Project	<b>IEEE 802.16 Broadband Wireless Access Working Group</b> < <a href="http://ieee802.org/16">http://ieee802.org/16</a> >	
Title	<b>Comments on relaying RNG-REQ message with RS basic CID at a transparent RS</b>	
Date Submitted	<b>2007-11-05</b>	
Source(s)	Kanchei (Ken) Loa, Yi-Hsueh Tsai, Yung-Ting Lee, Hua-Chiang Yin, Shiann-Tsong Sheu, Youn-Tai Lee,  Institute for Information Industry 8F, No. 218, Sec. 2, Dunhua S. Rd., Taipei City 106, Taiwan	Voice: +886-2-27399616 Fax: +886-2-23782328 loa@iii.org.tw
Re:	IEEE 802.16j-07/043: "IEEE 802.16 Working Group Working Group Letter Ballot #28"	
Abstract	This contribution proposes that the transparent RS should relay the received RNG-REQ message on the ranging CID.	
Purpose	Text proposal for 802.16j Baseline Document.	
Notice	<i>This document does not represent the agreed views of the IEEE 802.16 Working Group or any of its subgroups. It represents only the views of the participants listed in the "Source(s)" field above. It is offered as a basis for discussion. It is not binding on the contributor(s), who reserve(s) the right to add, amend or withdraw material contained herein.</i>

## Comments on relaying RNG-REQ message with RS ba

Figure 1 Verify the CMAC TLV of the RNG-REQ message at MR-BS with transparent RS

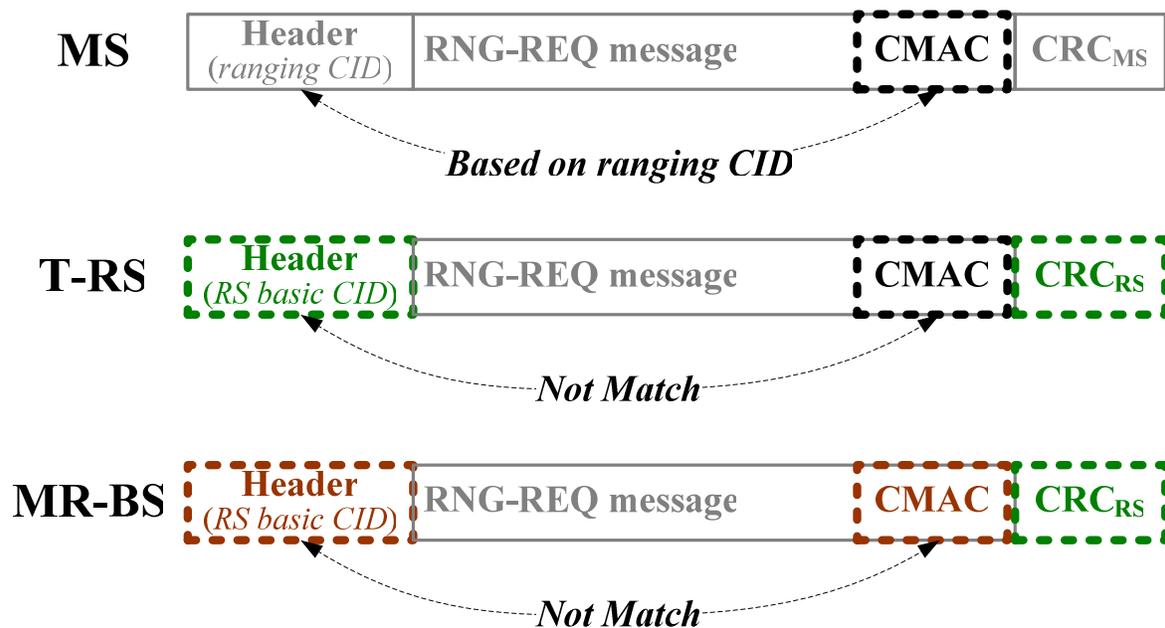
In the accepted comment #565 (contribution IEEE 802.16-07/459r6), the transparent RS must relay the received RNG-REQ message from MS to the MR-BS on the RS basic CID. Since RNG-REQ message for the association scan, location update, network re-entry, and handover procedure must contain the value of HMAC or CMAC, which is derived from the value of CID in the MAC header, the CMAC value in RNG-REQ message will become invalid after the transparent RS replaces the ranging CID by the RS basic CID (see Figure 1). The original idea of replacing the ranging CID by the RS basic CID is to identify the access transparent RS during the network entry procedure. However, in the MR system with transparent RSs, the access RS for a MS may be reassigned by the MR-BS whenever the MS performs the contention-based CDMA ranging. Therefore, it is not necessary to identify the access RS at this stage because the MS must send CDMA BR ranging in order to transmit the SBC-REQ right after receiving the RNG-RSP. Hence, we propose that the transparent RS must relay the received RNG-REQ message from MS to the MR-BS on the ranging CID.

- If adjustments are required, the MR-BS shall transmit the RNG-RSP to the SS and the process shall repeat. When the ranging code requires no further adjustment, the MR-BS shall provide an allocation in the access uplink for the SS to forward a RNG-REQ with its MAC address by inserting a CDMA\_Allocation\_IE in the UL-MAP. If management messages are relayed on the uplink, the MR-BS shall precede the CDMA\_Allocation\_IE with an UL\_Burst\_Receive\_IE containing the access RS’s basic CID. A transparent RS, whose CID matches the RS basic CID of the UL\_Burst\_Receive\_IE, shall receive the RNG-REQ on a burst specified by the CDMA\_Allocation\_IE and relay it to the MR-BS ~~on the RS basic CID.~~
